**MCPB
ITEM #13
7/27/06**

REVIEW TYPE: Preliminary Plan of Subdivision

PROJECT NAME: Radwick Lane

CASE NO. 120050600

Attachment B – Preliminary Plan

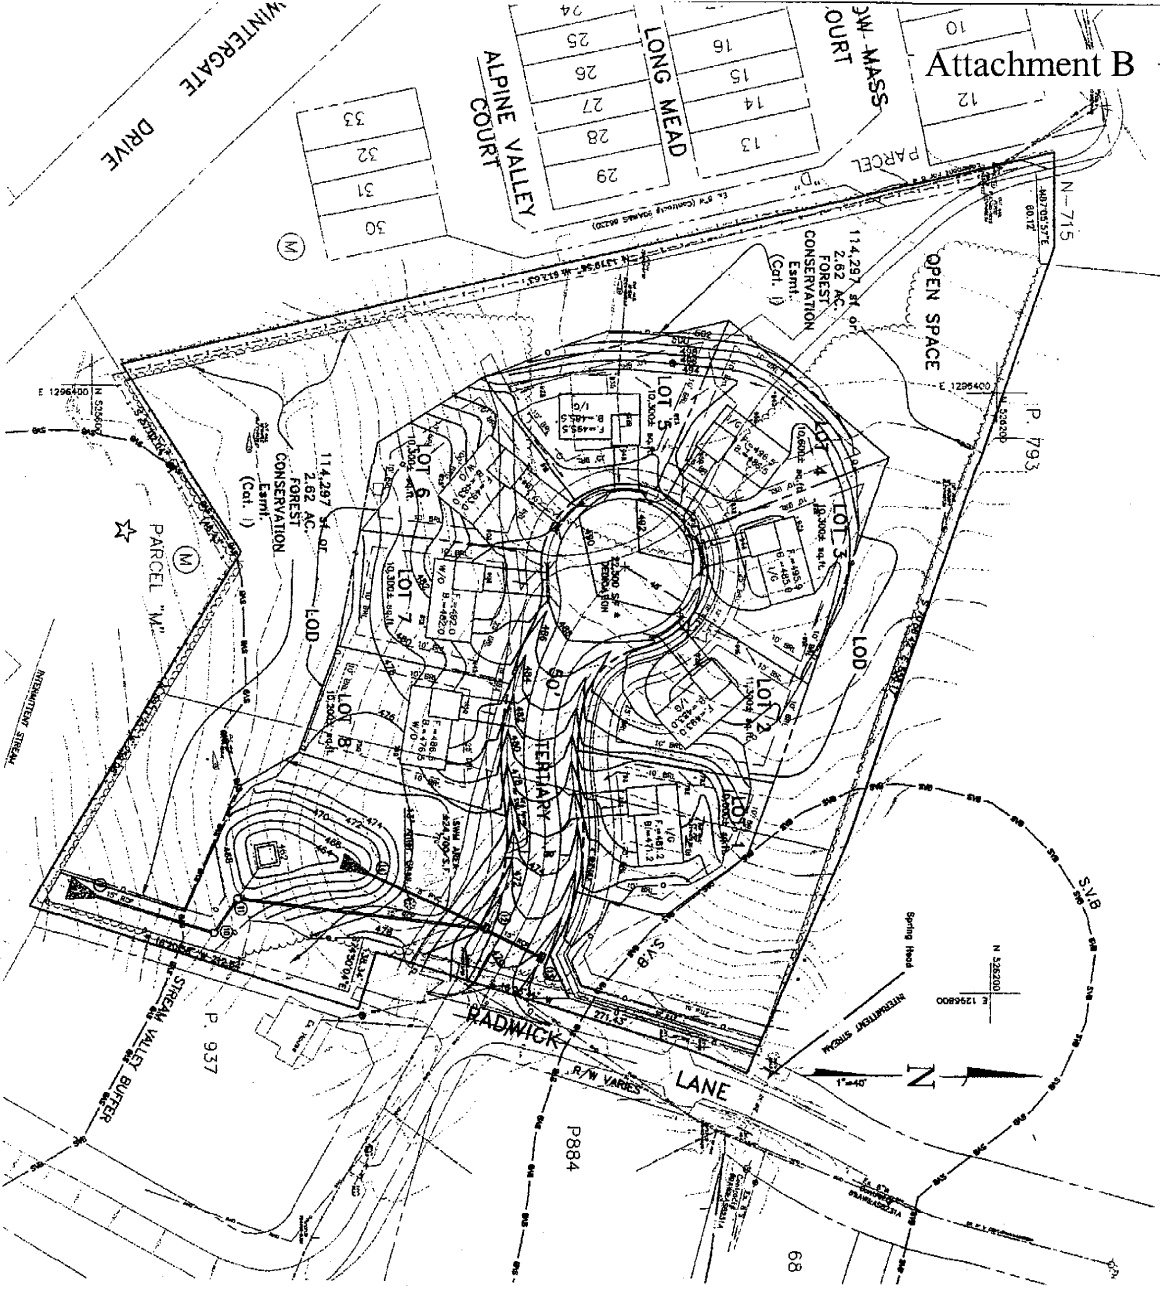
Staff Recommendation: Approval of the Preliminary Plan, including a waiver pursuant to §50-26(h)(3) to permit sidewalk on only one side of the proposed internal tertiary road, and subject to the following conditions:

- 1) Approval under this preliminary plan application is limited to eight (8) lots for eight (8) one-family detached residential dwelling units.
- 2) The applicant shall construct the proposed internal street as an open section, tertiary residential street within a 50 foot right-of-way.

- 4) Prior to the issuance of the last building permit, the applicant shall construct a five-foot sidewalk on the west side of Radwick Lane along the property frontage, and a five-foot wide sidewalk on only one side of the proposed internal street (north side), extended around the cul-de-sac to the driveway for proposed Lot 4.

- 6) The applicant shall construct a split-rail fence at the back of proposed Lots 1 through 8 to delineate the forest conservation easement. Access points into the easement will be permitted to allow passive use of the area by the residents.

Staff concludes that the subject preliminary plan will provide safe and adequate access for vehicles and pedestrians, and satisfies the APF requirements. A waiver of sidewalk on one side of the proposed internal road is being recommended to help reduce the overall level of impervious surfaces on the property, thereby reducing the amount of stormwater runoff generated and treated in the on-site stormwater management facility. Staff believes that pedestrians will be able to safely use the roadway and remaining sidewalk.
